ACCESSION NBR: 8311220223 DOC. DATE: 83/11/15 NOTARIZED: NO DOCKET #
 FACIL: 50-397 WPPSS Nuclear Project, Unit 2, Washington Public Powe 05000397
 AUTH. NAME: SØRENSEN, G.C. AUTHOR AFFILIATION: Washington Public Power Supply System
 RECIP. NAME: SCHWENCER, A. RECIPIENT AFFILIATION: Licensing Branch 2

SUBJECT: Forwards revised pages to FSAR Section 8.3 re undervoltage protection, per telcon request. Changes will be reflected in FSAR Amend 34.

Subject: * NUCLEAR PROJECT NO. 2
 FINAL SAFETY ANALYSIS REPORT
 SECTION 8.3, UPDATE

TABLE 8.3-23

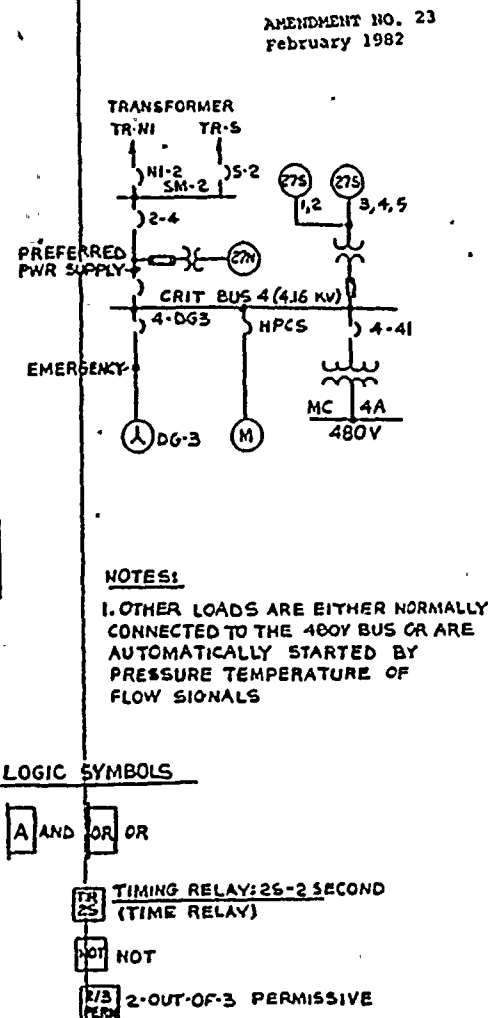
<u>Transformer</u>	<u>Taps</u>
TR-S	-5.0% -2.5%
TR-B	+2.5%
TR-N1	-2.5%
TR-N2	-2.5%
TR-1-11	-2.5% 0%
TR-2-21	-2.5% 0%
TR-3-31	-2.5% 0%
TR-7-71	-2.5% 0%
TR-8-73	-5.0% -2.5%
TR-8-81	-5.0% -2.5%
TR-8-83	-5.0% -2.5%
TR-4-41	-2.5% 0%
TR-4-53	-2.5%
